SUBJECT: Parking Scheme update for Princes Parade, Hythe.

Road Safety Assessment Princes Parade, Hythe

Proposed Parking Layout Options

Road Safety Assessment

Drawing Title
Parking Meter Locations

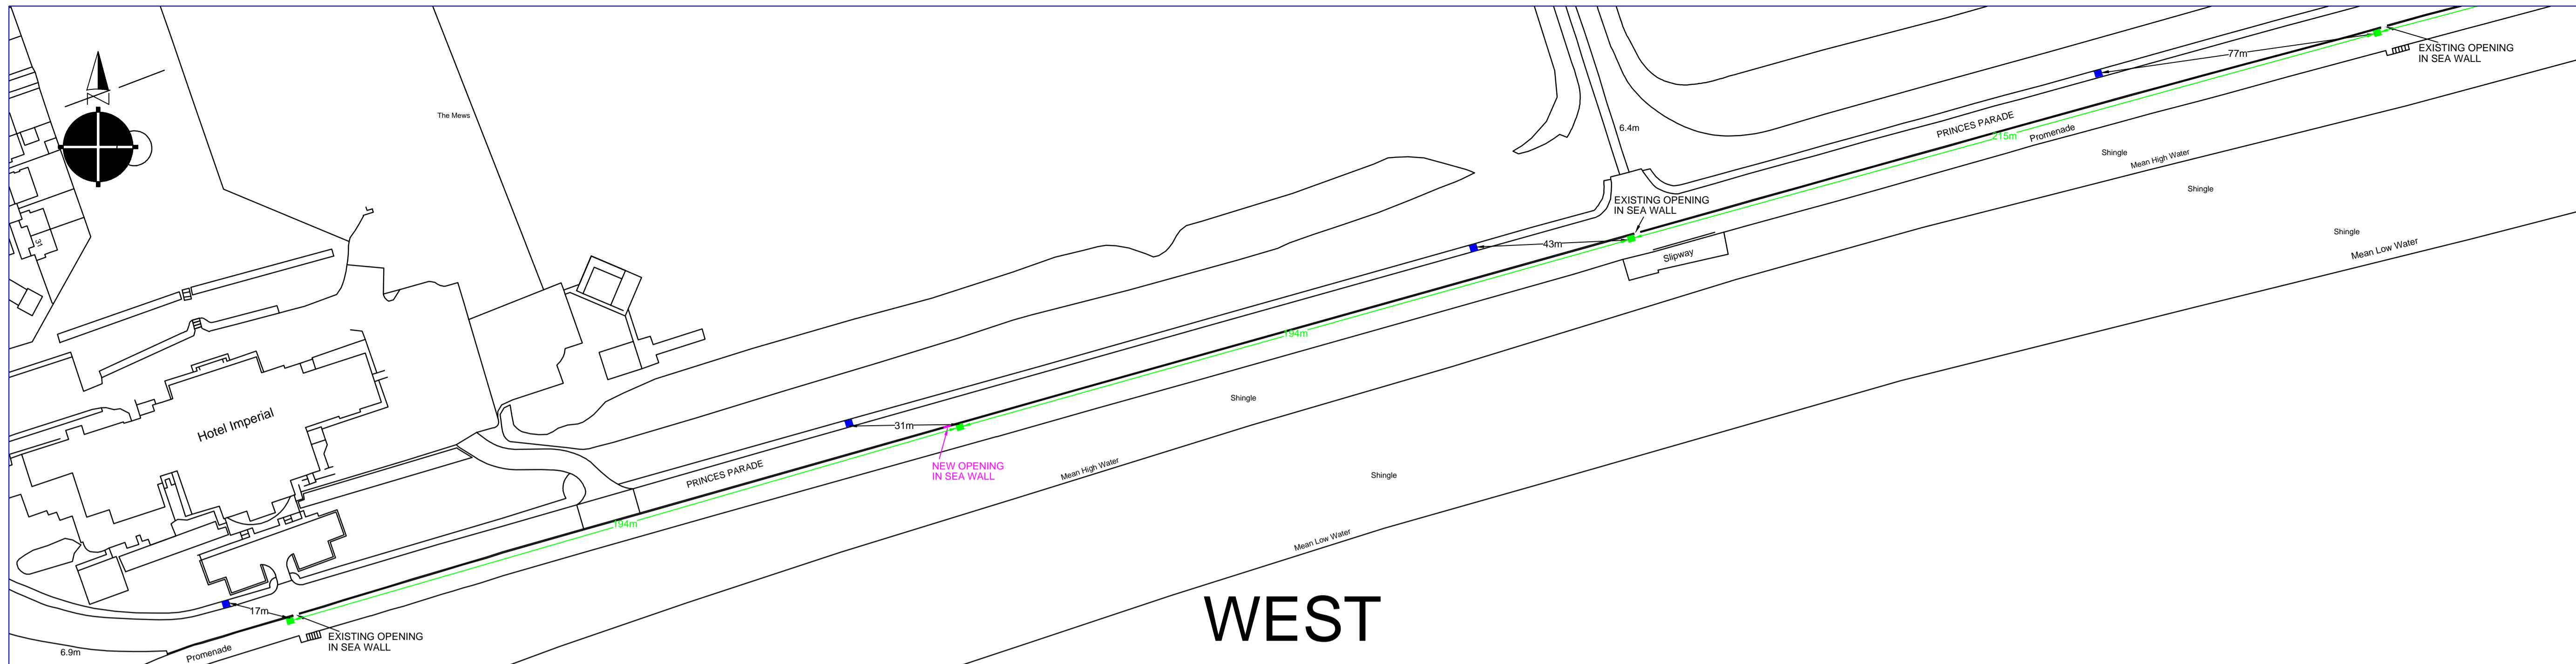
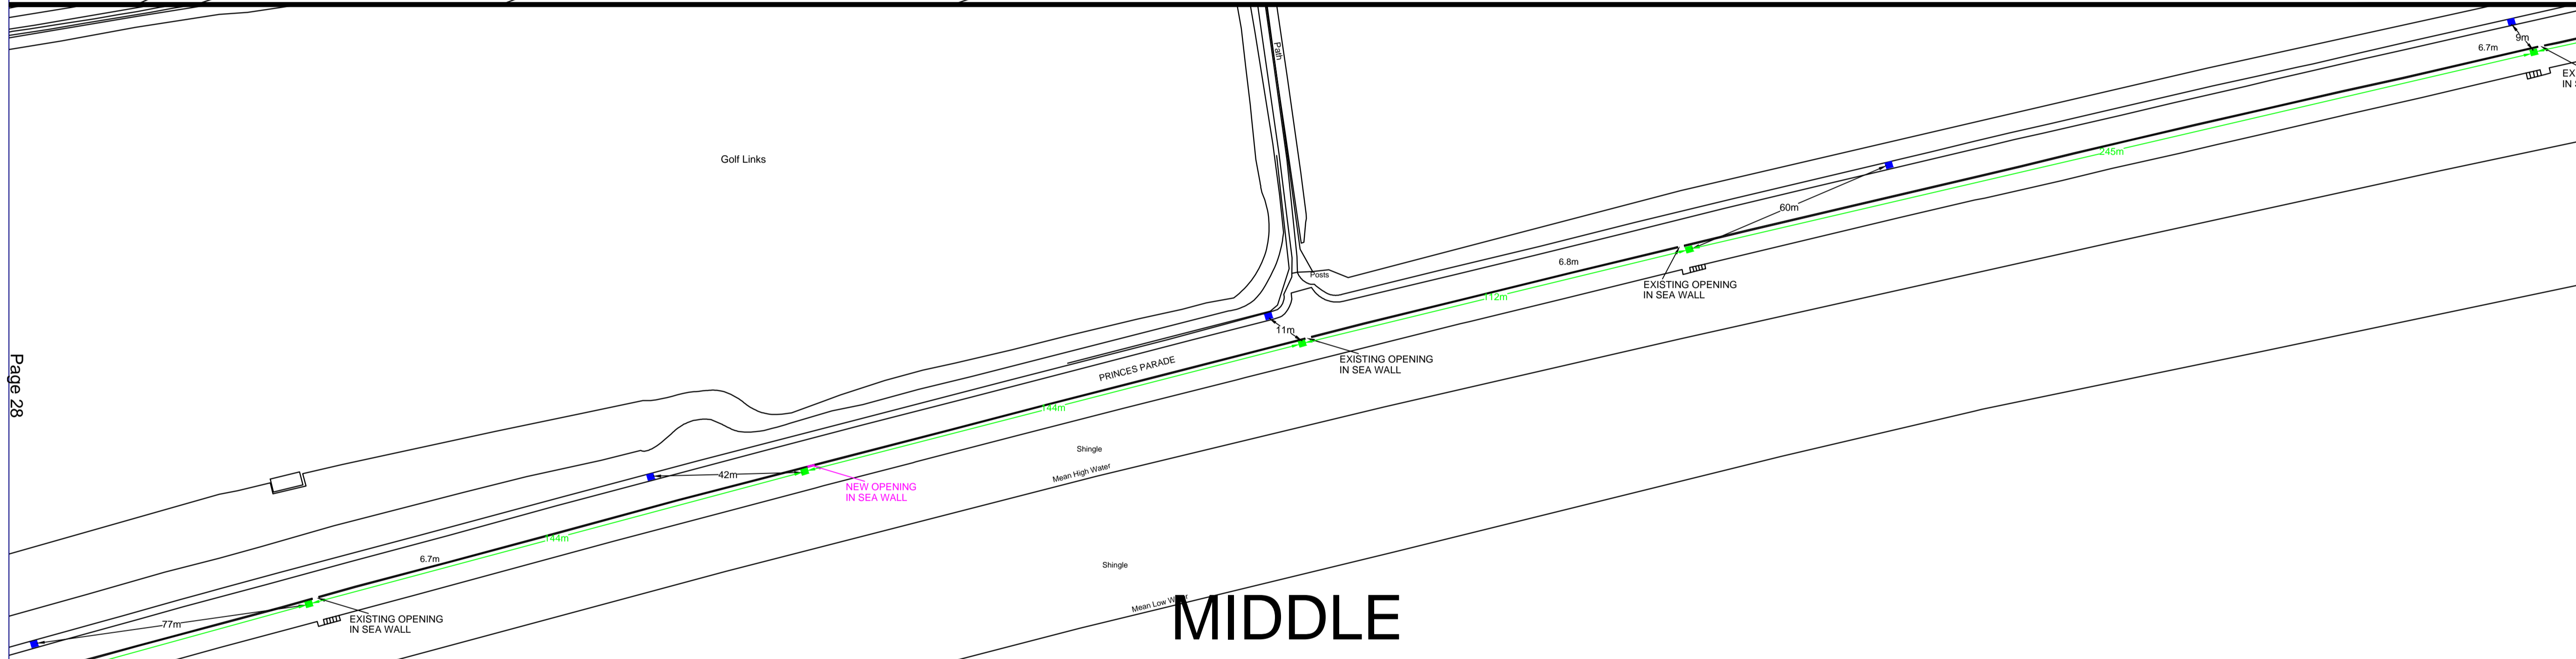
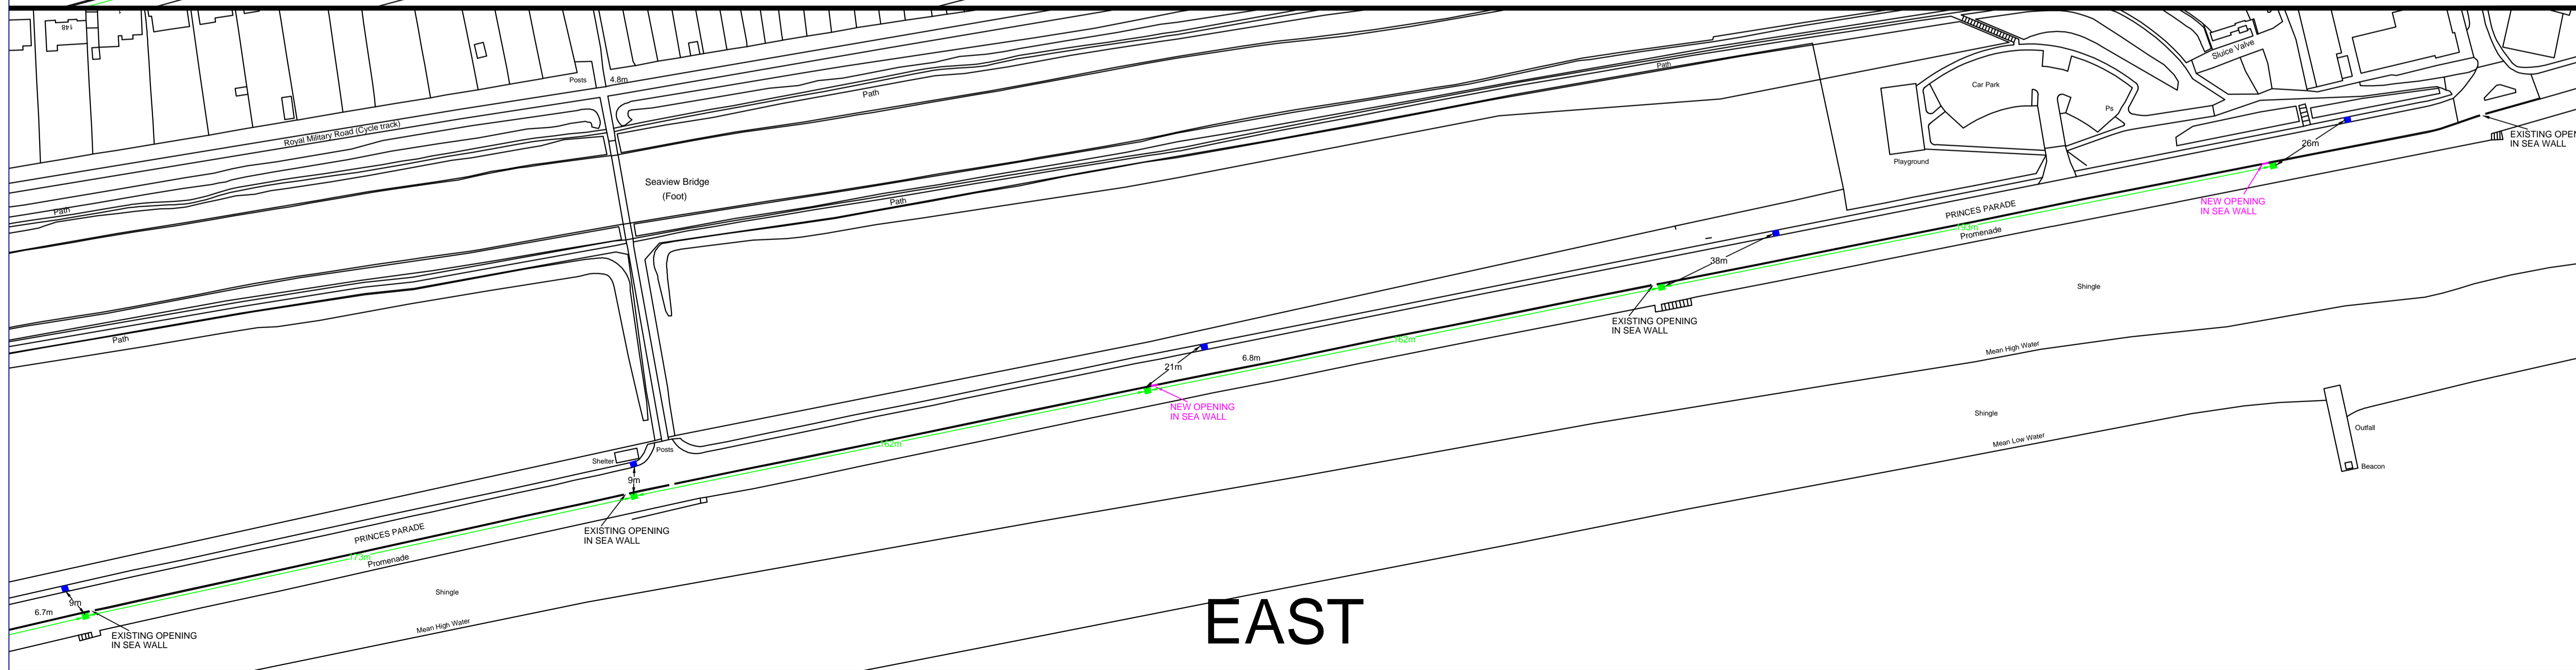
Machines may be safely installed on the promenade and half turned so that the machine screens face away from the sea.

Having carefully considered the evidence that has been made available option 3 seems to have the greatest merit. Much of the existing situation remains unchanged and it appears that the visiting public is able to cope safely with this situation. The repositioning of the "pay-and-display" ticket machines to the beach side of the carriageway avoids the need for any increase in pedestrian crossing movements across Princes Parade and the proposed increase in the number of gaps in the sea wall will give more opportunities for pedestrians to more easily access the promenade and the beach area with all the attendant safety benefits of not being exposed to the live traffic for longer than necessary.
